DRAINAGE PLAN AND REPORT

16140 OLD DENVER ROAD

February 3, 2017

SUBJECT: Drainage Plan and Report
All About Outdoor Storage PPR-16-037

Stormwater Detention and Infiltration Design Data Sheet

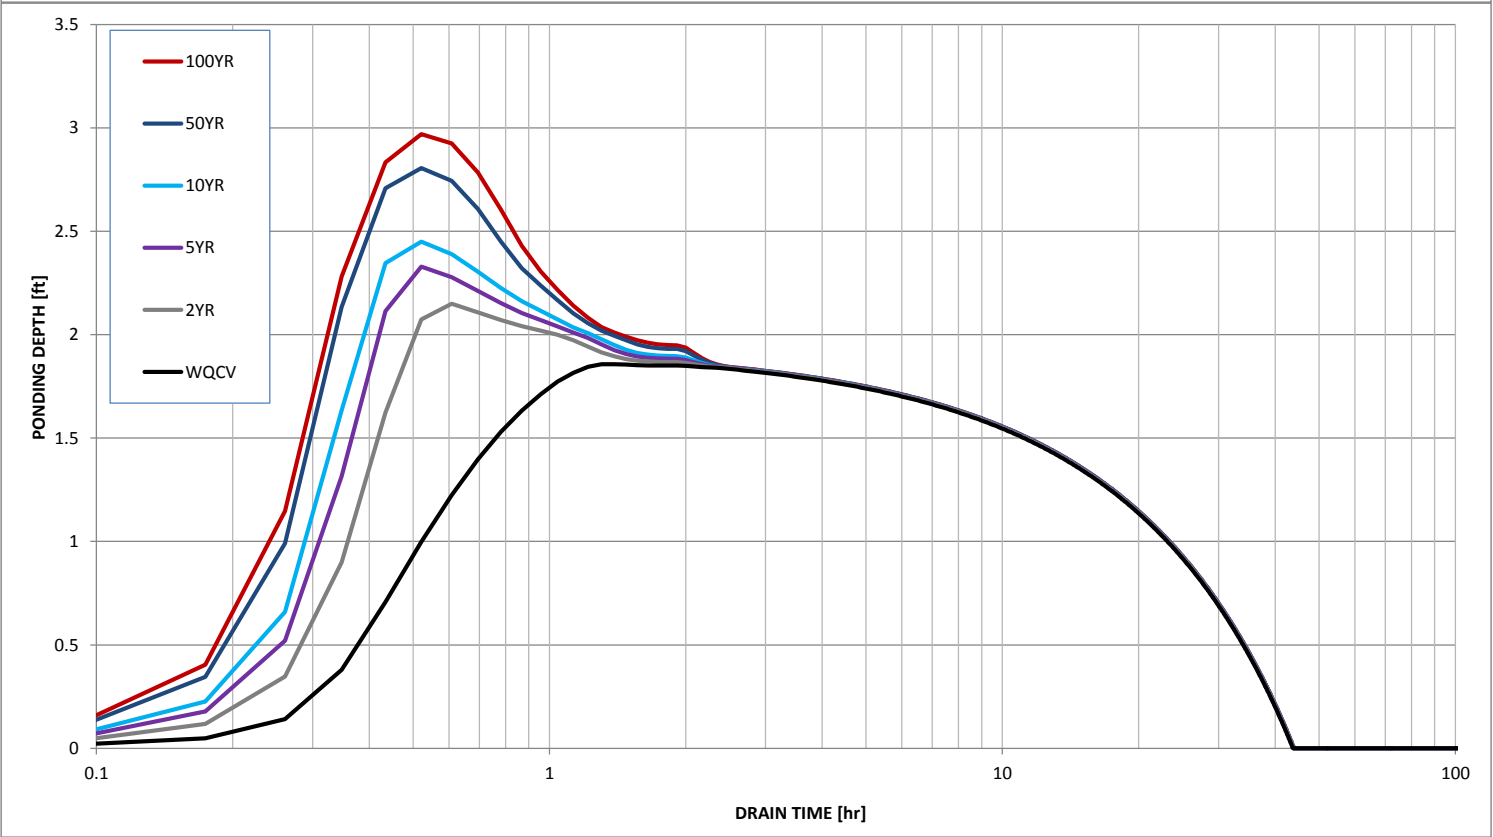
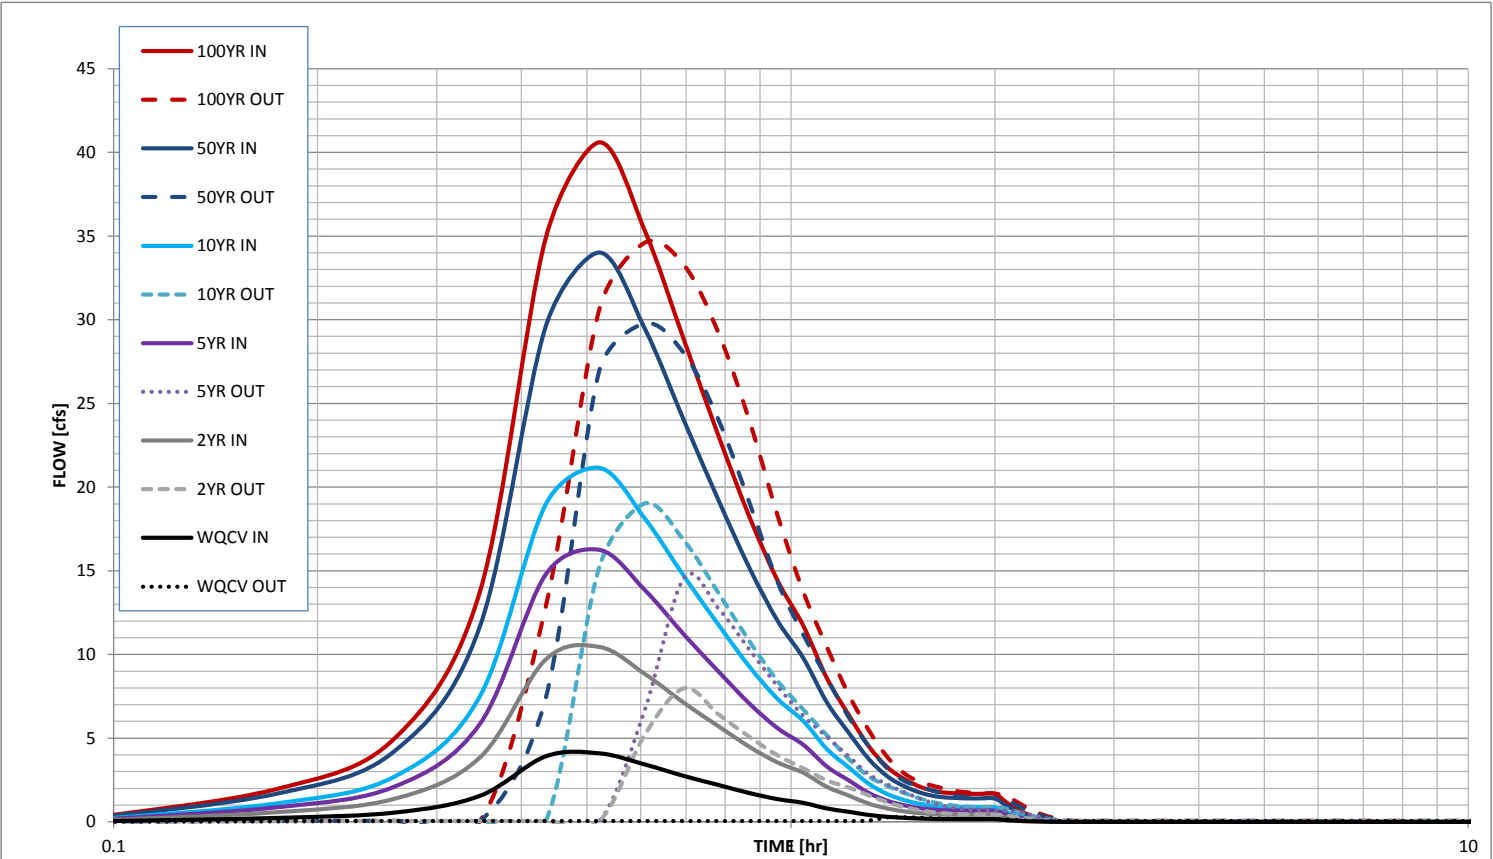
1. Revise to Sand Filter per the UD-Detention worksheet.
2. Remove the SDI Worksheet from the drainage report and upload it the dedicated SDI Worksheet slot in the electronic submittal.

DETENTION BASIN STAGE STORAGE TABLE BUILDER

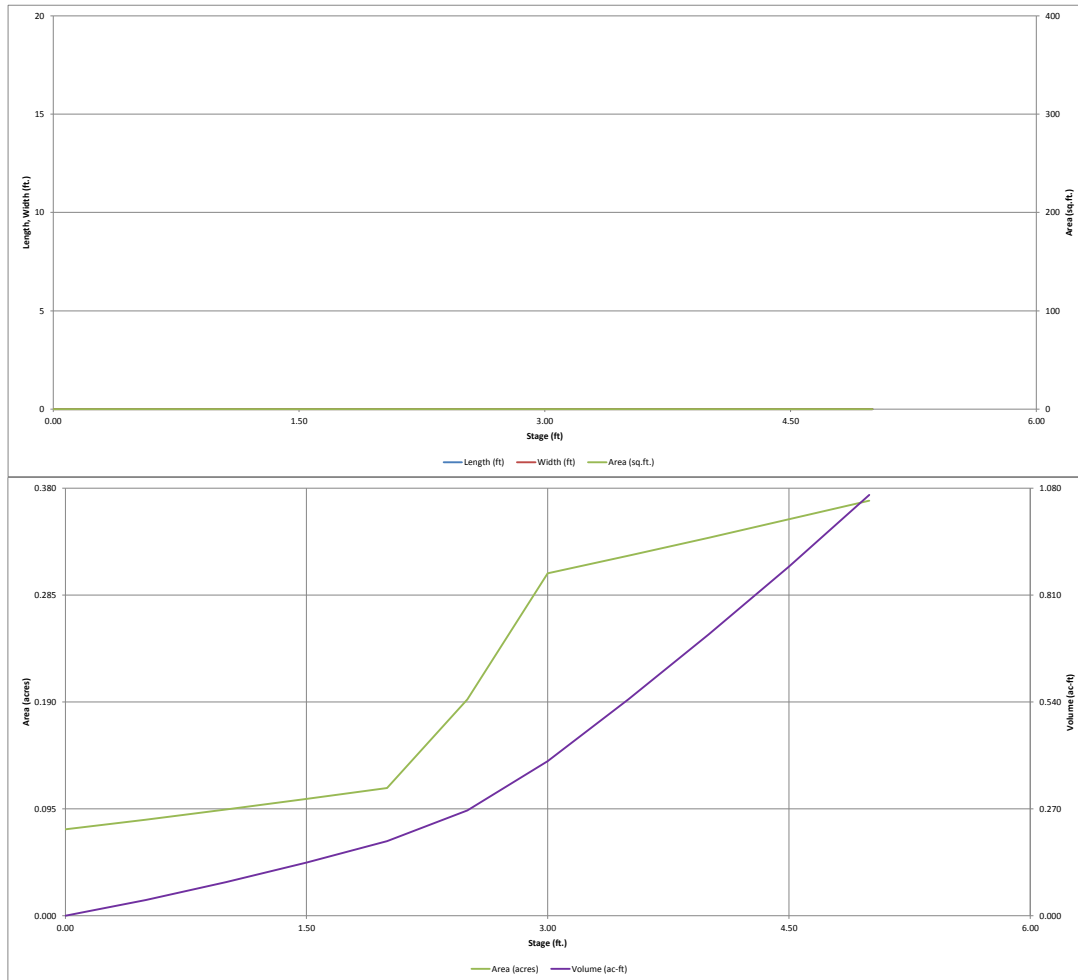
Note the corresponding actual elevation in the description.

Provide the calculation for the watershed imperviousness.

Spillway invert must be above the 100yr storage volume

Submit the outlet structure design tab of the UD-Detention worksheet.

- calculation for underdrain orifice diameter to match WQCV drain time is missing.
- The design does not appear to meet full spectrum detention.

No restriction is in place to release design storm return periods below 100yr at or below historic rate.

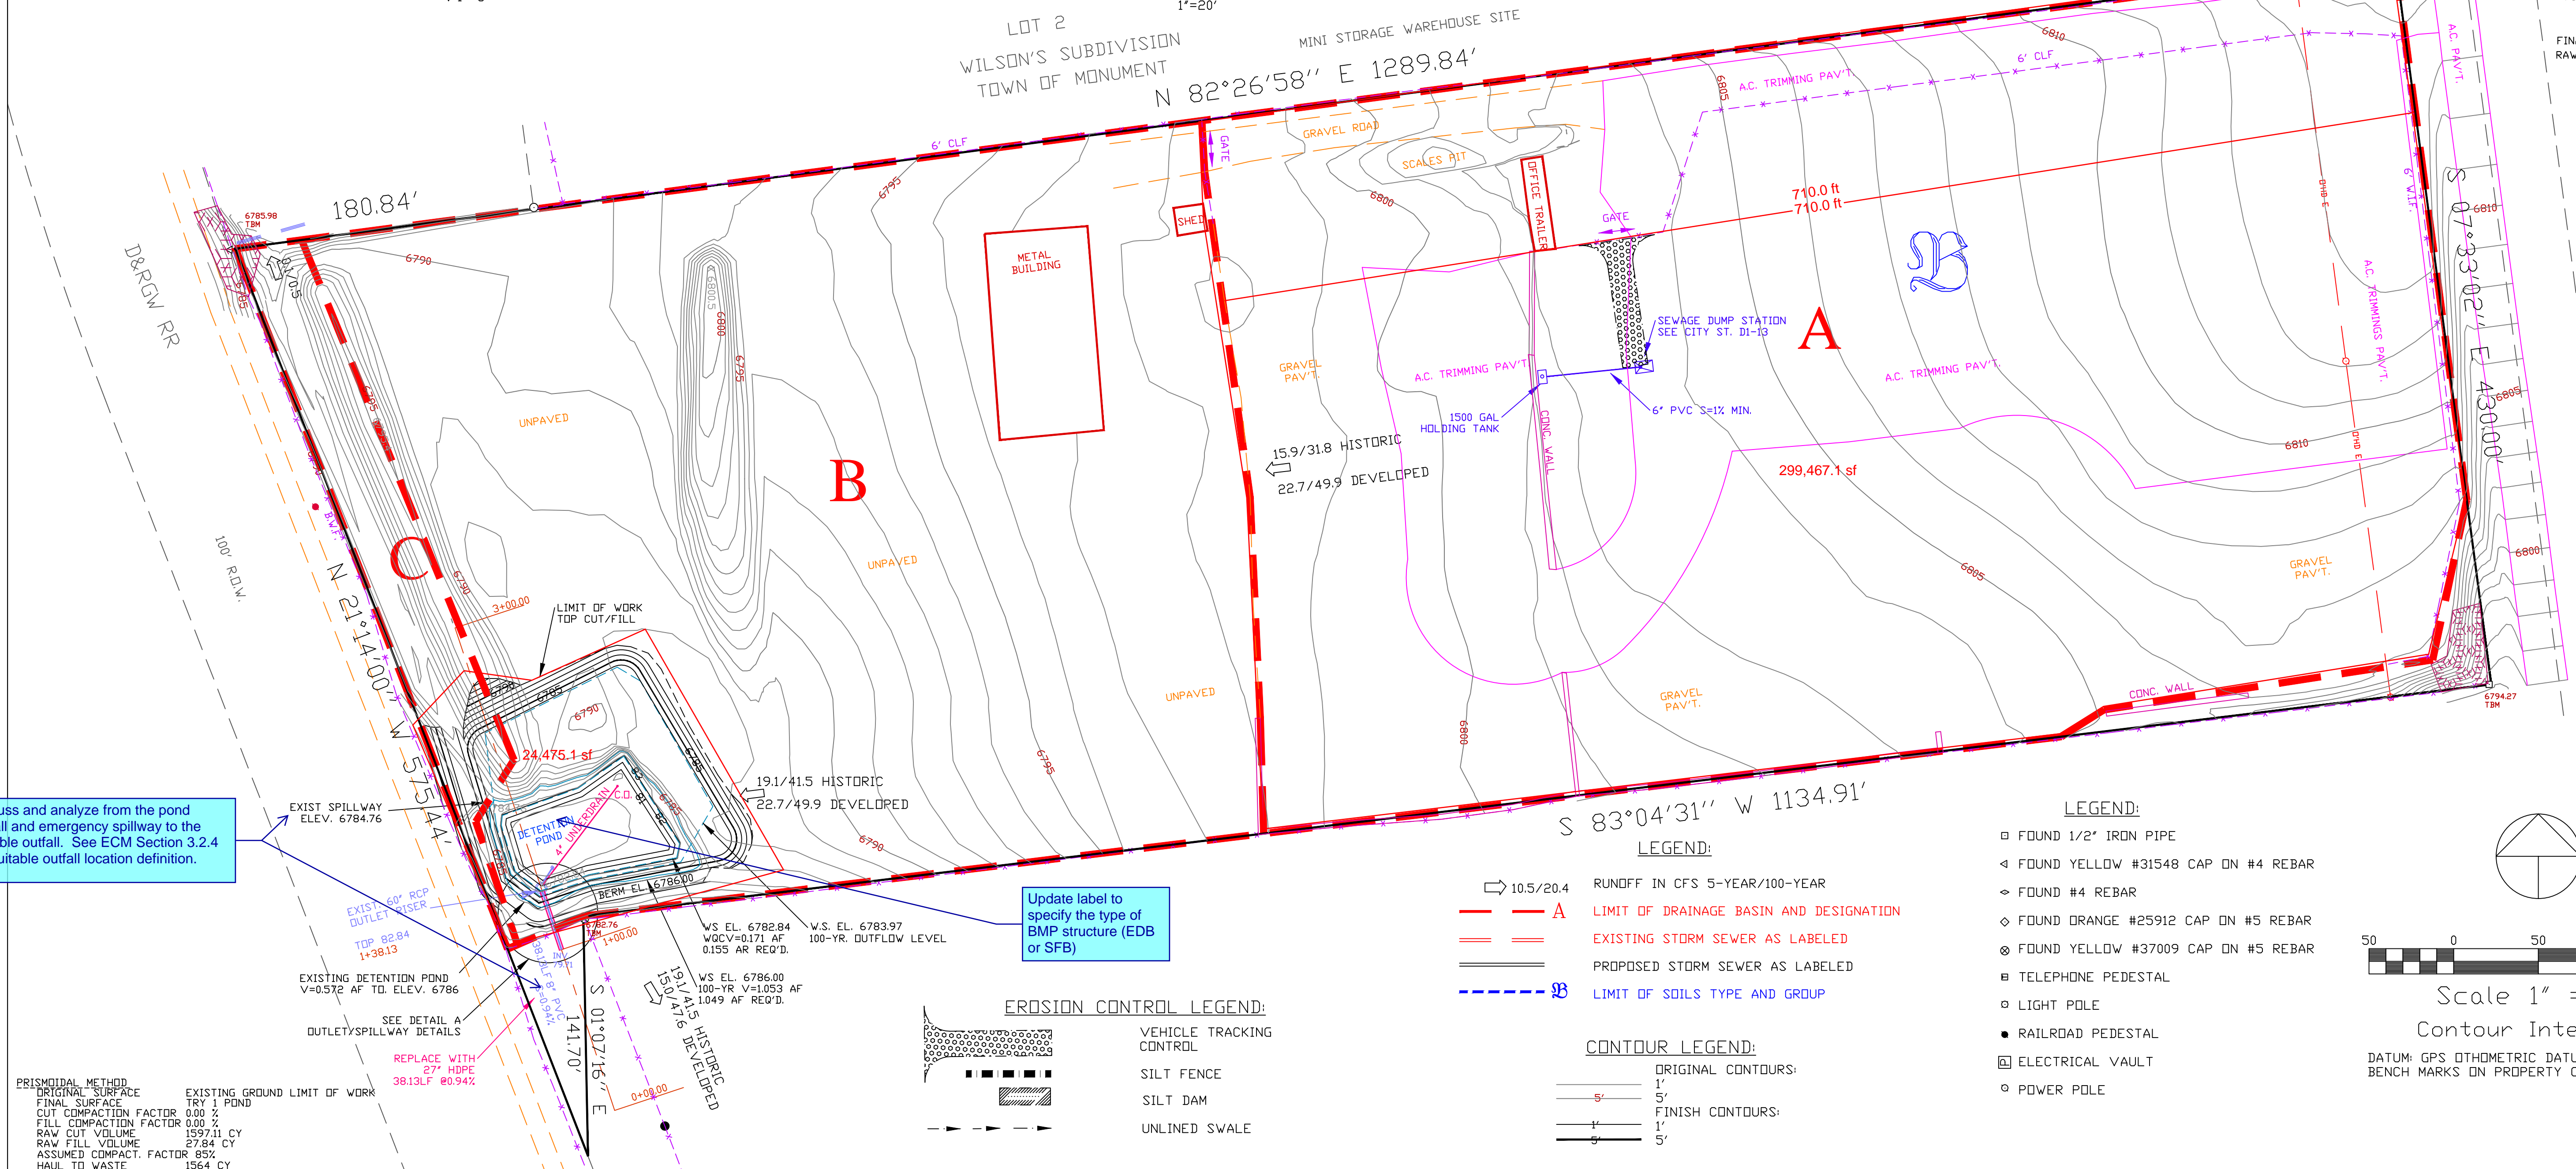
Discuss and analyze from the pond outfall and emergency spillway to the suitable outfall. See ECM Section 3.2.4 for suitable outfall location definition.

Update label to specify the type of BMP structure (EDB or SFB)
